Technical change to 7/8" T-distributor

The 7/8" T-distributors will be changed after a transitional period.

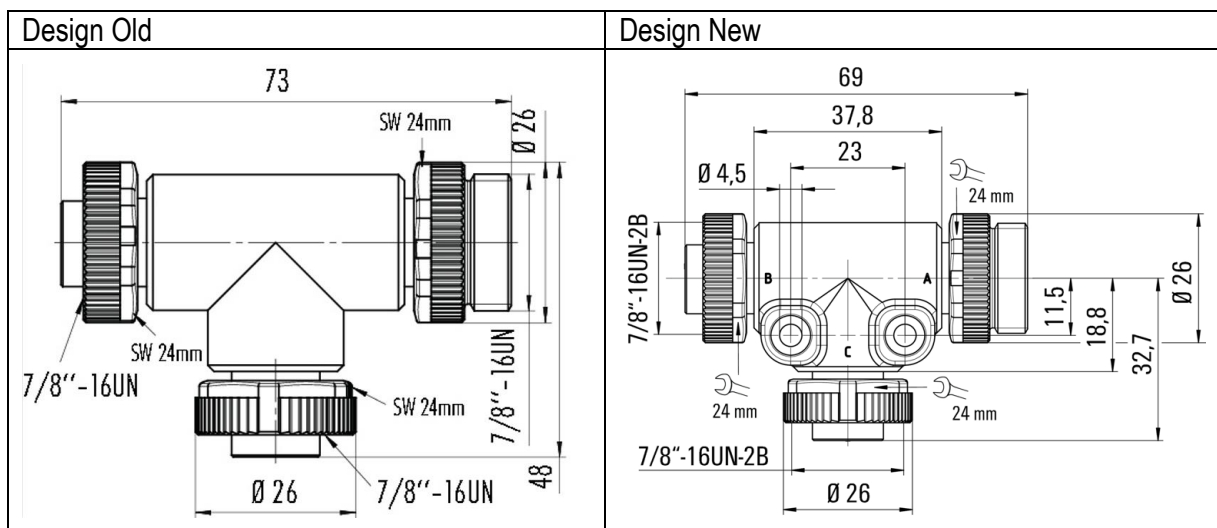
Previously, the 7/8" T-distributors were designed without mounting holes, which made them difficult to attach. In the new design, in addition to the integration of mounting holes, the design has also been minimized, making the design even more compact. This optimizes and simplifies the installation of the products. All other technical specifications remain identical.
